UNITED STATES
NUCLEAR REGULATORY COMMISSION
WASHINGTON, D.C. 20555-0001

LICENSEE: Tennessee Valley Authority (TVA)
FACILITY: Sequoyah Nuclear Plant, Unit 1
SUBJECT: SUMMARY OF MAY 14, 2012, PUBLIC TELEPHONE CALL WITH TVA
REGARDING HEAVY LOAD LIFTS LICENSE AMENDMENT REQUEST -
(REQUEST FOR ADDITIONAL INFORMATION ASSOCIATED WITH RISK)
(TAC NO. ME7225)

DISCUSSION ITEMS

Figure 3-259. Annual probability of exceedance of peak ground acceleration: Sequoyah site.

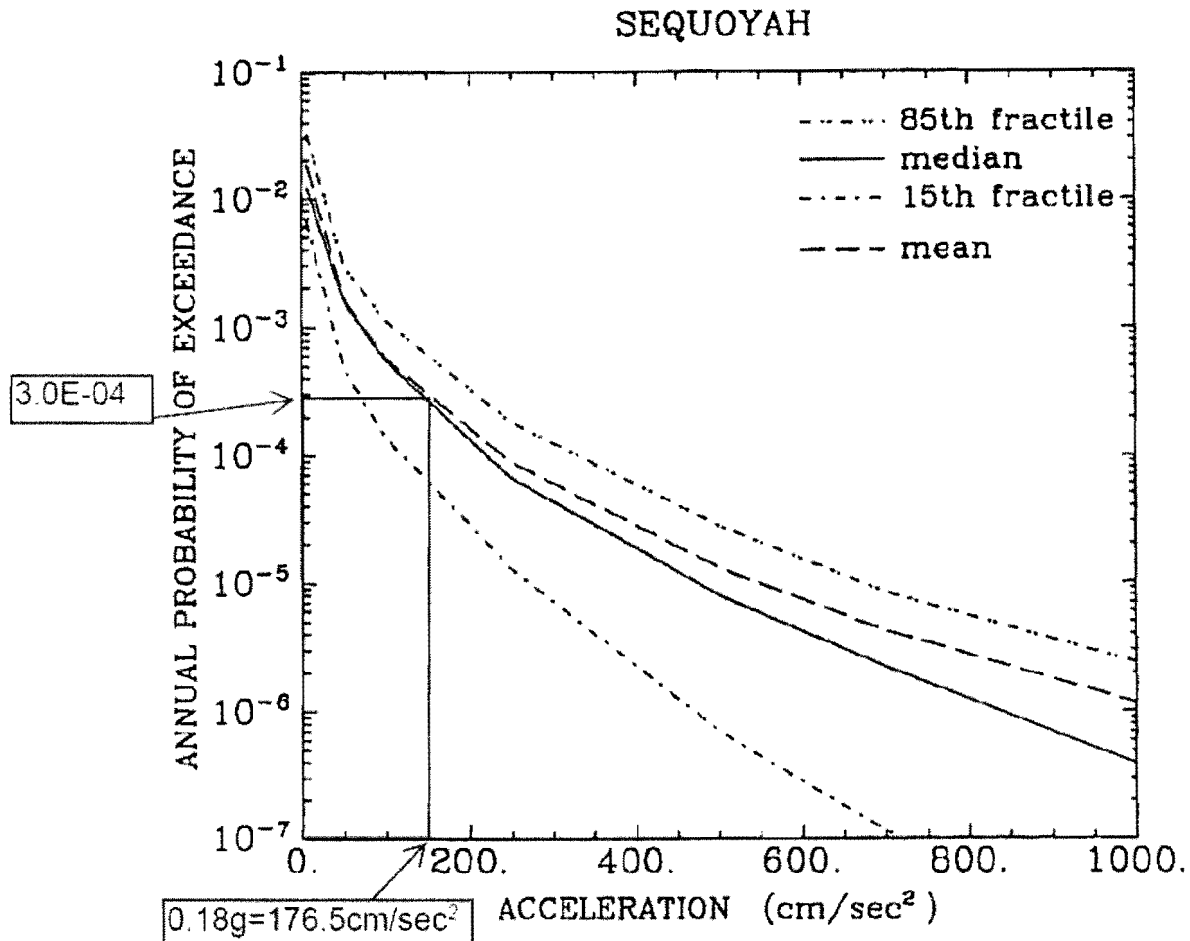
Page 31 of the submittal dated September 29, 2011 [Agency-wide Documents Access and Management System (ADAMS) Accession No. ML11273A169] (submittal), states that, "the OLS [outside lift system] will not collapse or drop a load while loaded or unloaded during the SSE." What is the probability of a seismic event exceeding the SSE [safe shutdown earthquake] (or, alternatively, the strength of the OLS) while the OLS is loaded? If the risk from a seismic event could be significant compared to the random lift drop, please include this risk in your change in core damage frequency [CDF], and large early release frequency [LERF] estimates.

The Sequoyah Nuclear Plant Updated Final Safety Analysis Report, Section 2.5.2.4, defines the Safe Shutdown Earthquake (SSE) maximum ground acceleration of 0.18 g [acceleration due to gravity] or 176.5 centimeters/second². Using the following figure from the EPRI [Electric Power Research Institute] report NP-6995-D, "Probabilistic Seismic Hazard Evaluations at Nuclear Plant Sites in the Central and Eastern United States: Resolution of the Charleston Earthquake Issue," the frequency of a seismic event exceeding the SSE is 3.0E-04 per year.

Each load lift is estimated [to] take one hour to complete. Since there are eighteen load lifts, the total time during which the OLS will be loaded is eighteen hours. To calculate the probability of having a beyond SSE event while the OLS is loaded, the frequency of the seismic event exceeding the SSE ($3.0\text{E-}4$) was multiplied by the duration, in years, of the OLS being loaded ($18 \text{ hrs} / 8760 \text{ hrs per yr}$). The calculated probability of this event is $6.16\text{E-}07$. This probability is well below the annual probability of having a random lift load drop, which is $1.017\text{E-}03$, and is therefore not included in the Core Damage Frequency (CDF) and Large Early Release Frequency (LERF) analysis.
